Groundwater Transfer Review Summary Form

Transfer/PA # T- 14074

Application: T-14074

Applicant Name: Kameron DeLashmutt / Pinnacle Utilities, LLC

Adjacent Well Measurements and Deep Canyon Spring Elevation

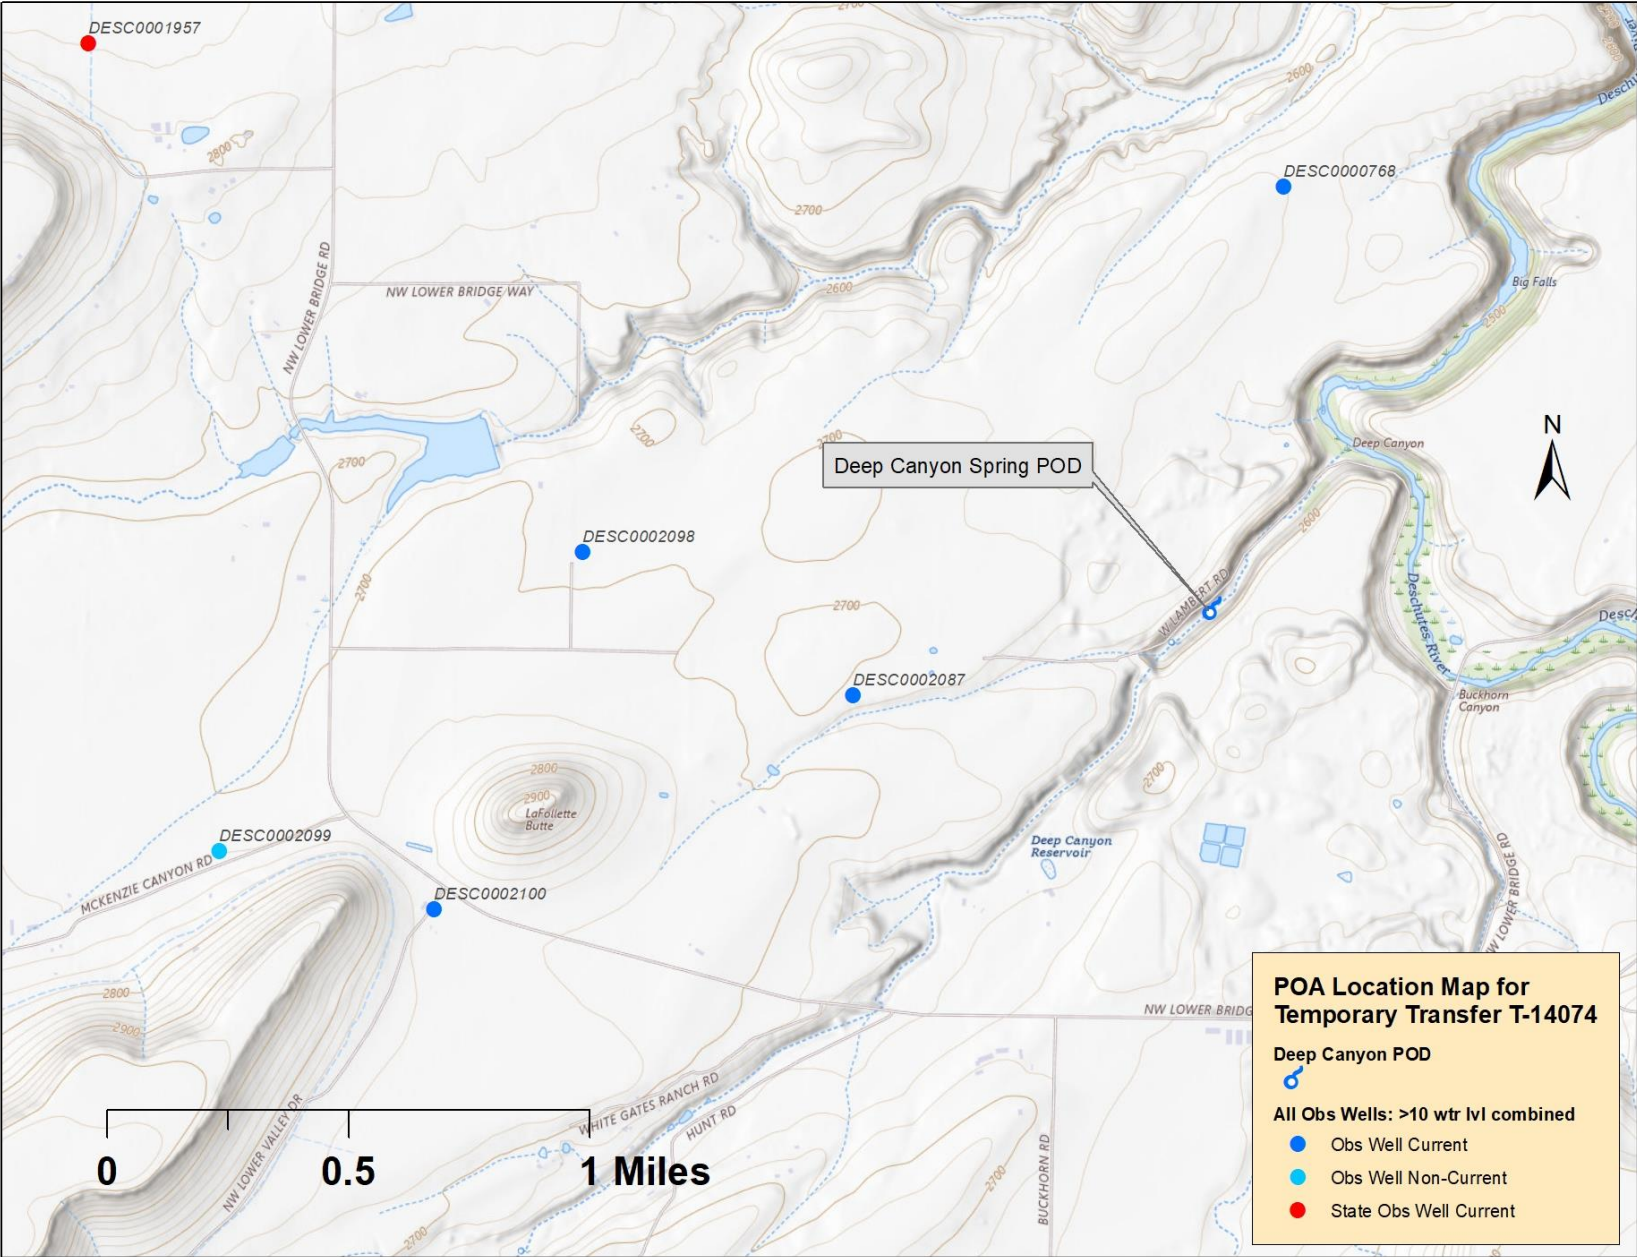
b) If yes, for each POA identify the reference level, most recent spring-high water level, and whether an applicable permit decline condition has been exceeded: Flow at Deep Canyon Creek is a condition for use of water that depends on a groundwater gradient providing flow at a valid POD. Deep Canyon Creek originates as Deep Canyon Spring and runs for approximately 2500 feet before meeting the Deschutes River. Adjacent groundwater levels have declined regularly since the mid-1990s. Recent measurements at Deep Canyon Creek/Springs reflect a significant reduction in flowrate. The water available at POD (less than 0.2 cfs in 2025) is much less than is authorized in the originating certificates for this transfer and for the amount that is requested to be transferred. Thus, the proposed changes in this transfer appear to meet the definition of enlargement per OAR 690-380-0100(2)(d).

Hydrograph of Water Levels of the To Wells and From Wells

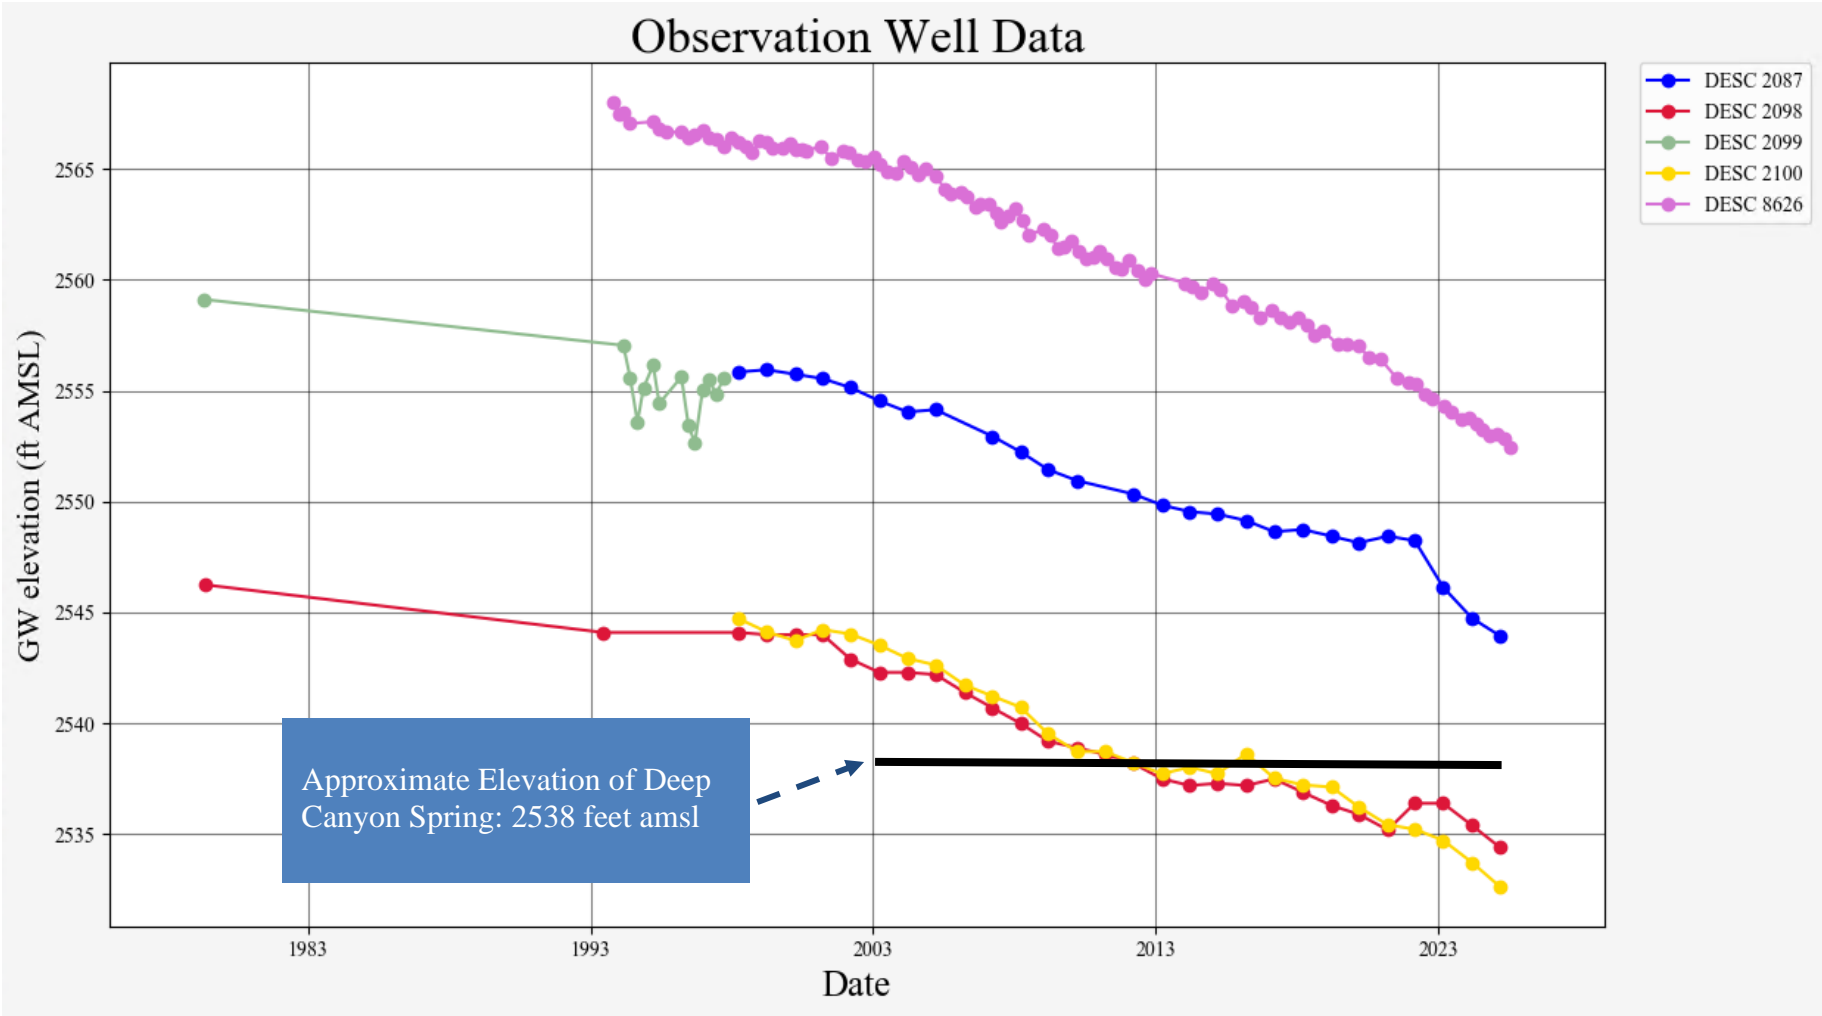
☒ Yes ☐ No Comments: The proposed changes will move groundwater use from the Lower Bridge area to the Cline Buttes area. This will likely result in an increase in well-to-well interference with adjacent groundwater users in the Cline Buttes area.

- ☐ Yes ☒ No If yes, explain: Considering the high permeability and storage of the Deschutes Formation as well as the considerable saturated thickness, it is not likely that the proposed changes would increase well-to-well interference enough to be considered injury to another groundwater user.
